# **Presentation to ATWIS Hearing Panel**

## **Gaiety Hall**

## **11 February 2025**

**for Friends of Banks Peninsula Inc**

# Actual vs modelled flows

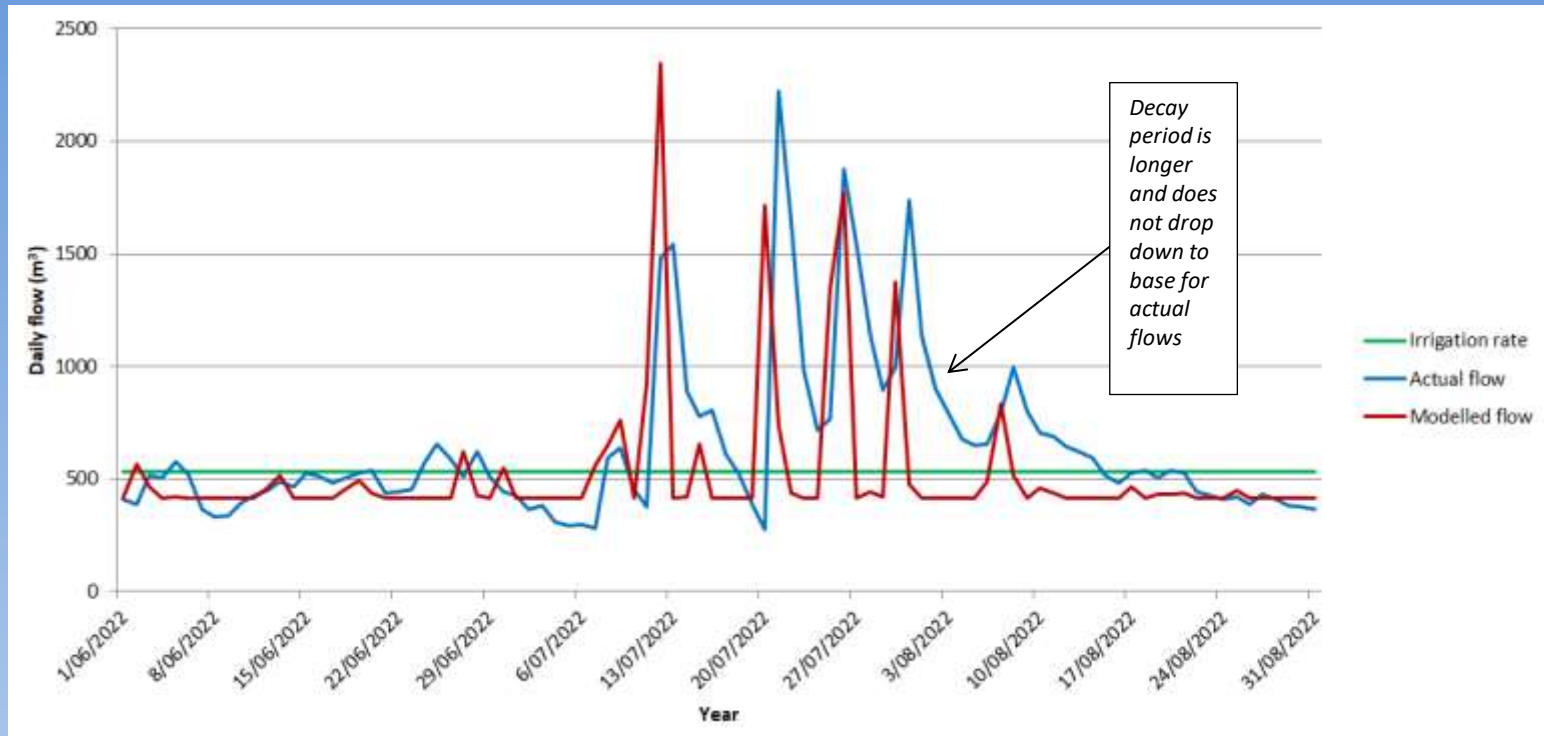
- Dr Martin identifies source of error on this graph
- Beca/PDP modelled flows do not adequately capture the long period it takes for soil to drain in prolonged wet weather
- Elevated I&I during this period but has not been accounted for

# Recent spreadsheet reveals major anomaly

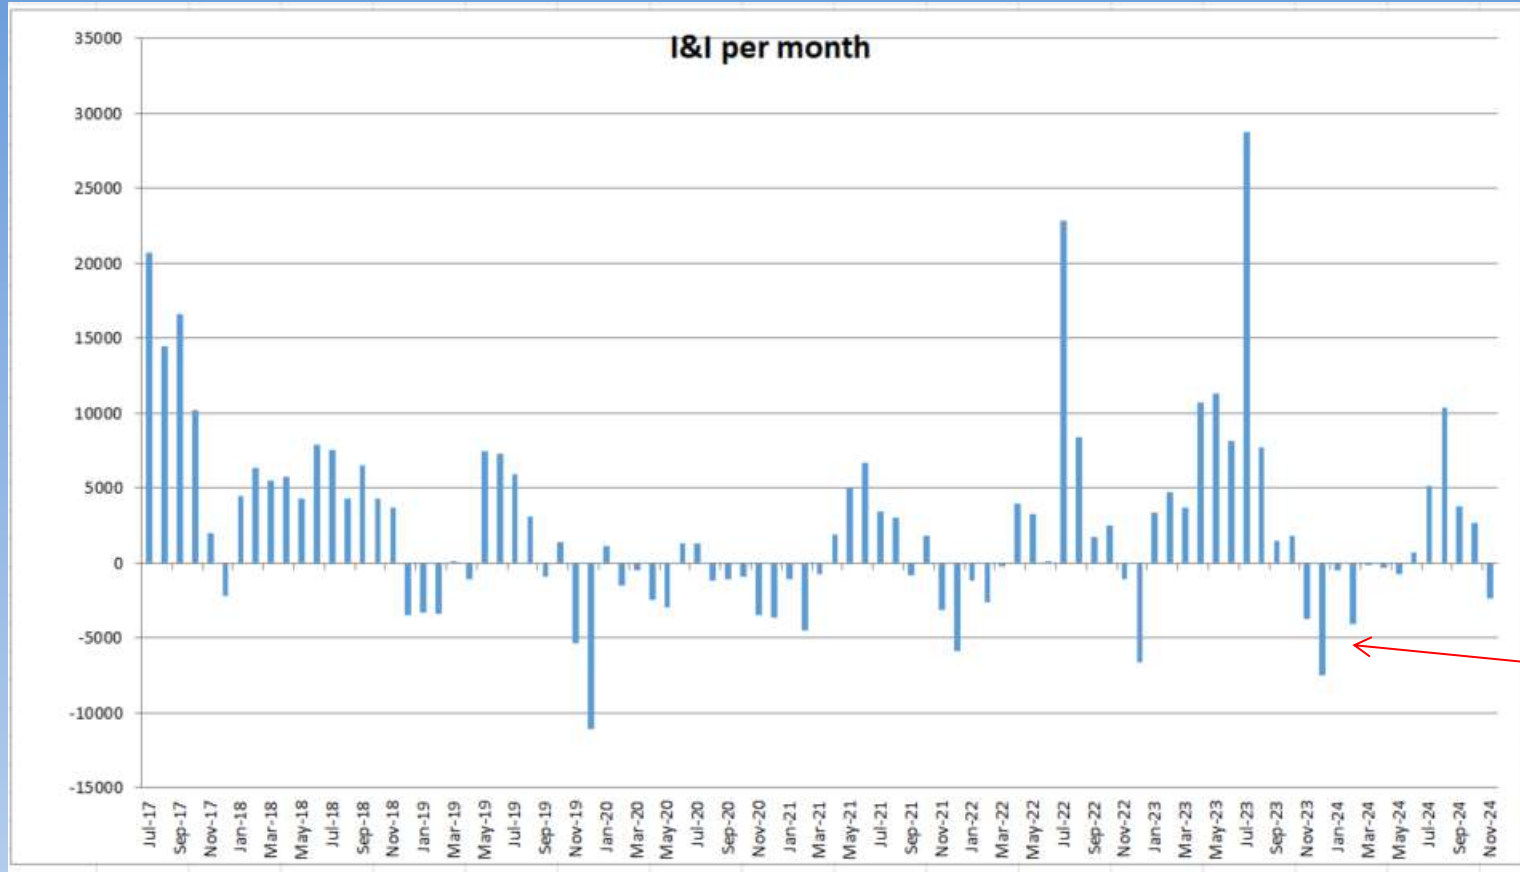
Negative I&I  
calculated

# Slopes now greater than 19 degrees

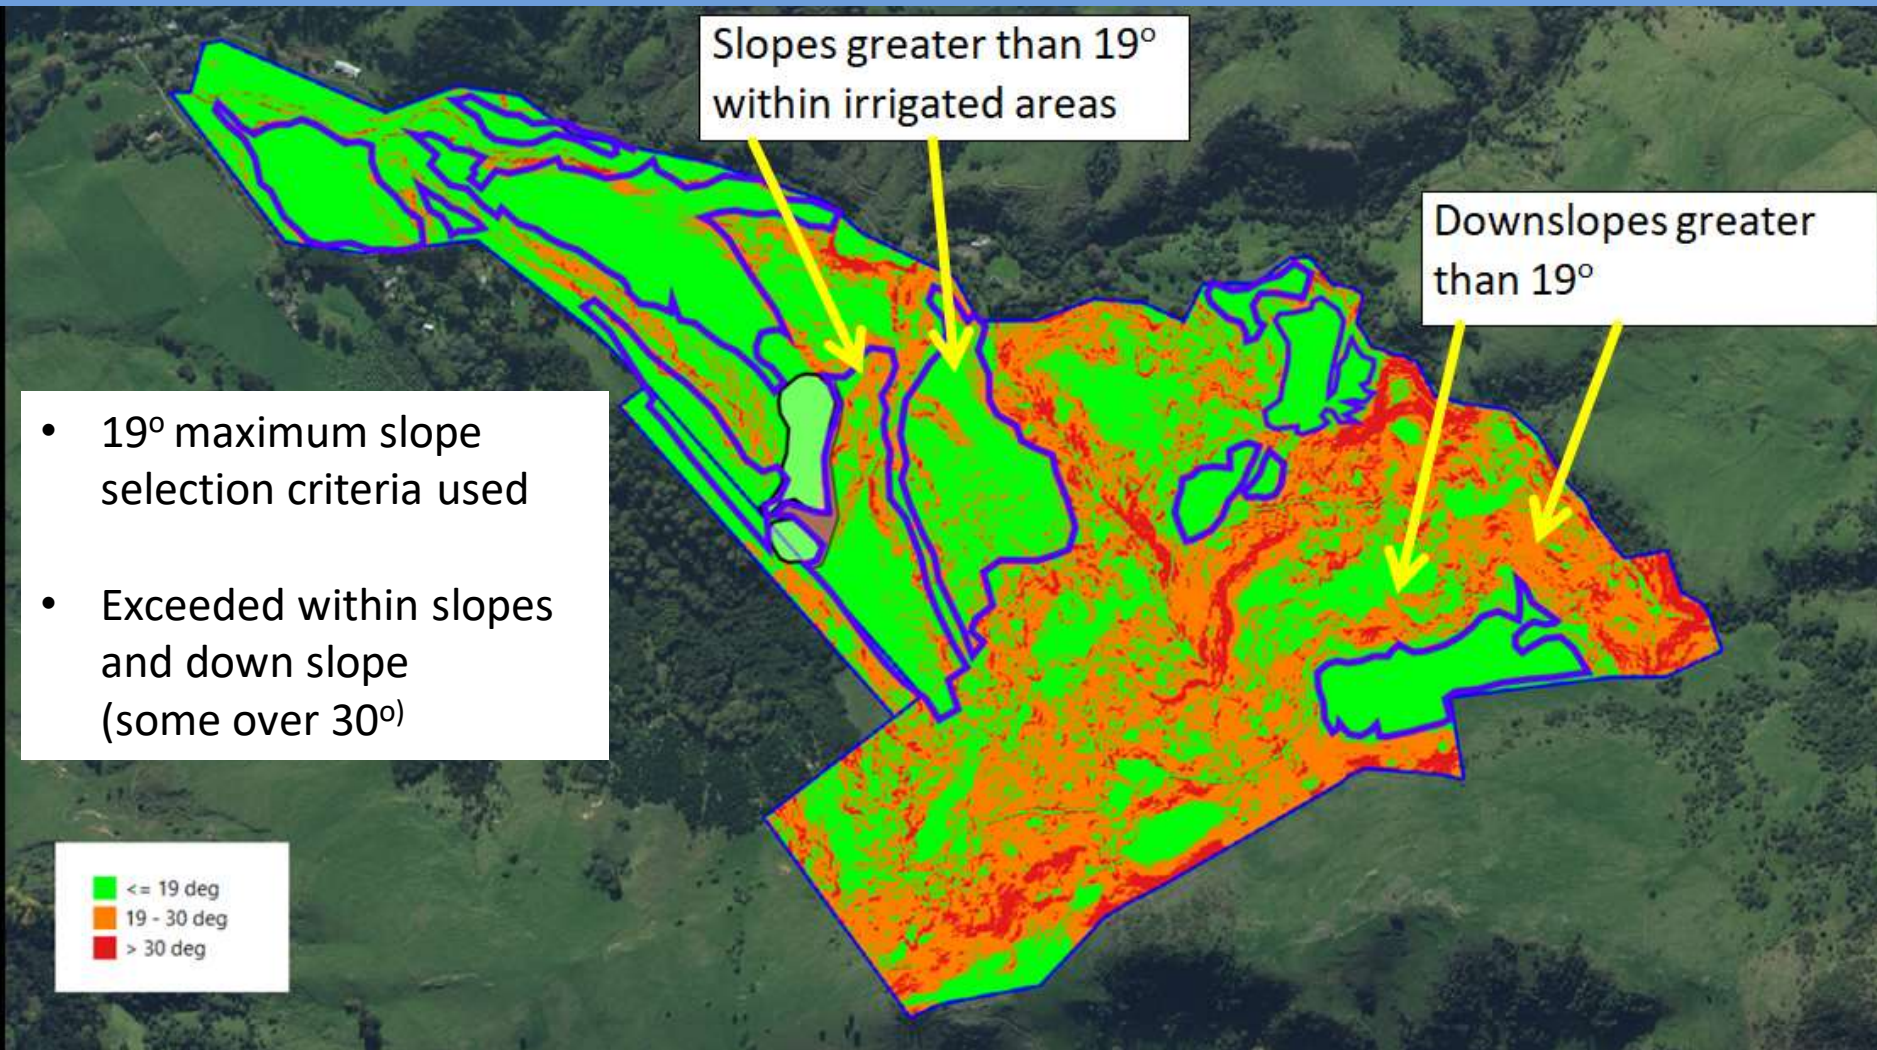
- Slope criteria maximum of 19° rules out steeper land even if very low irrigation rates used
- Mr Offer confirms this in his recent evidence.

# Effect of delayed restart

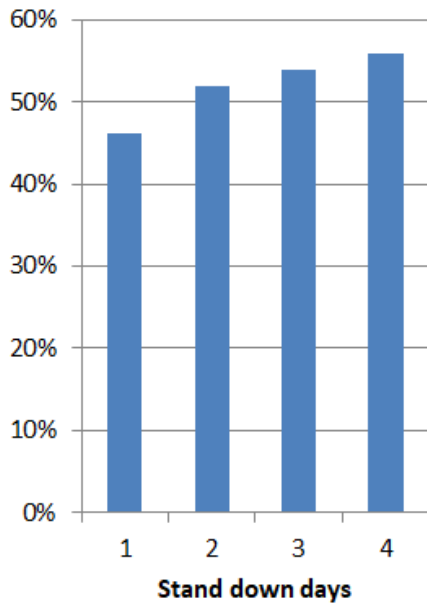
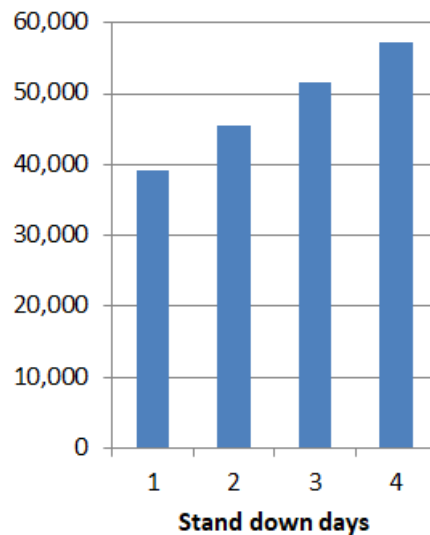
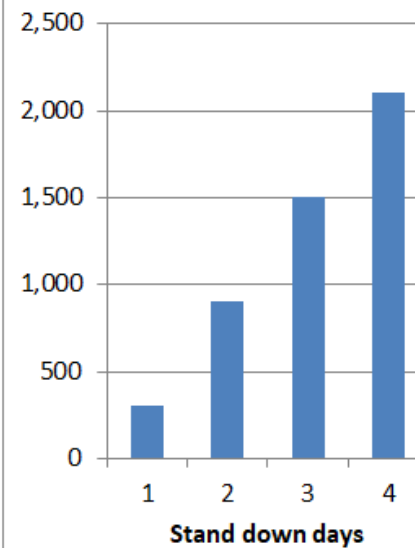
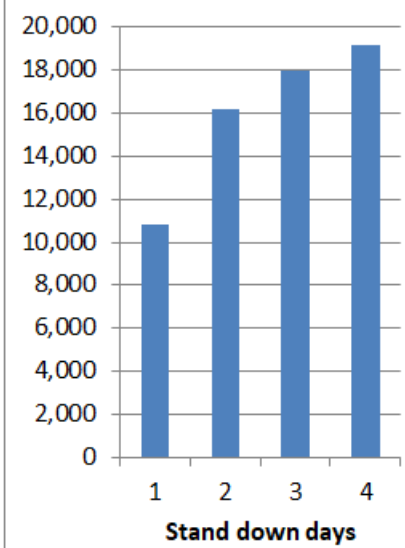
- Irrigating to soil moisture increases exceedances
- Size of effect varies by year and cutoff

# Effect of irrigating to field capacity

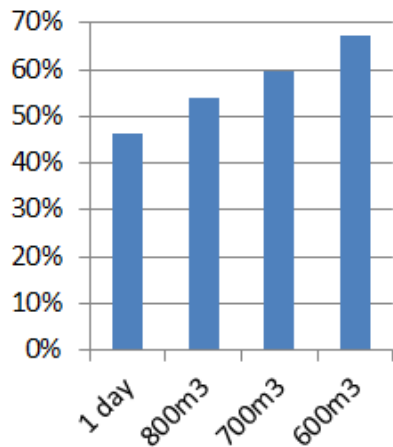
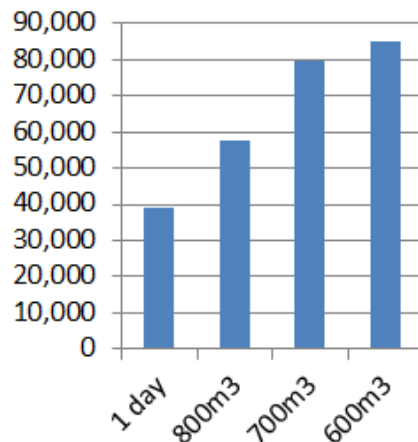
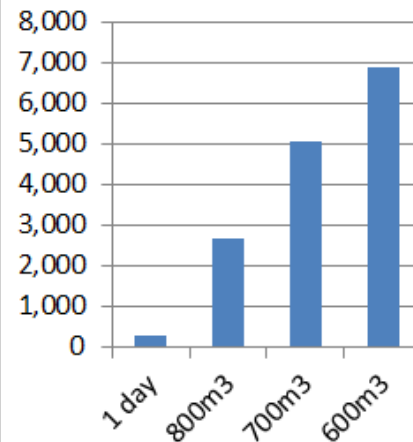
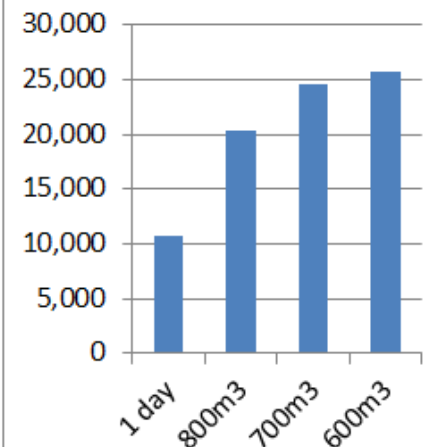
- With 800m³ cutoff exceedances are similar to 4-day standown
- With 600m³ cutoff the effect is doubled

# Effect of reduced area

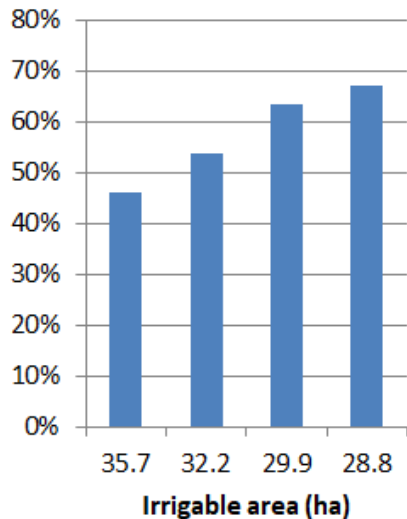
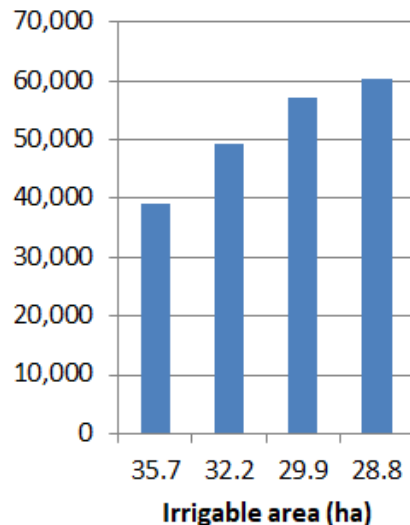
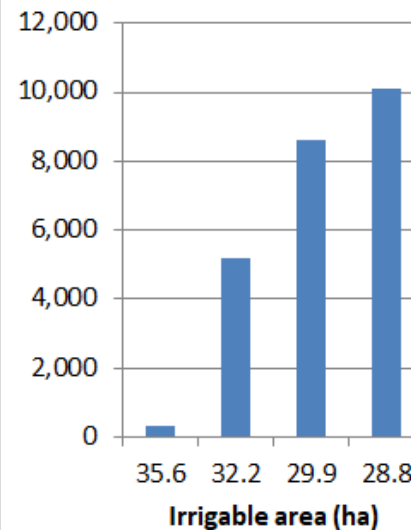
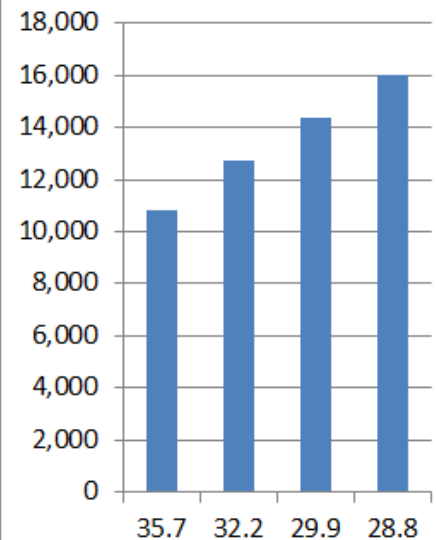
- Loss of all upper areas increases exceedances to 67% of all years
- Exceedance volumes for wet years increase by 50%

# Combined parameter effects

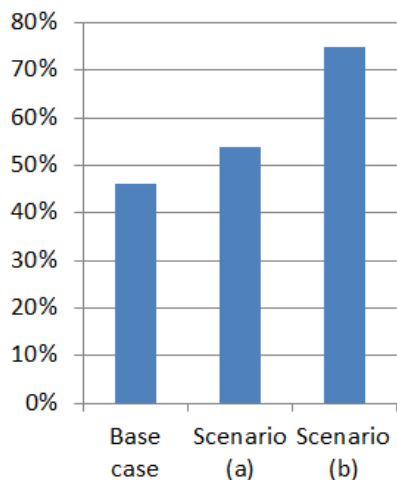
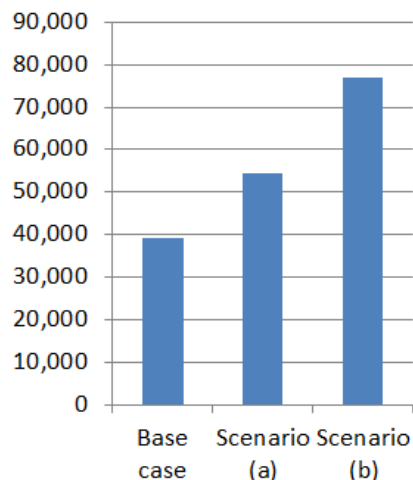
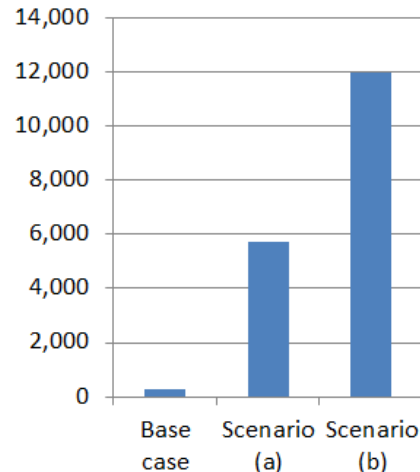
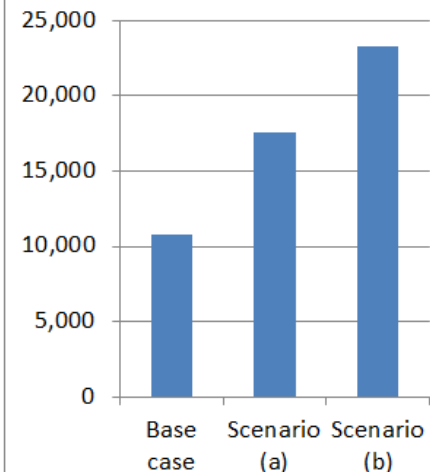
- Three combinations:
  - Base case: 35.7 ha, restart next dry day
  - Scenario (a): 32.2 ha, restart after 2 days
  - Scenario (b): 28.8 ha, restart when flows below 800m<sup>3</sup>
- Scenario (b):
  - Increases Exceedance years from 46% to 75% of all years
  - Doubles exceedances volumes
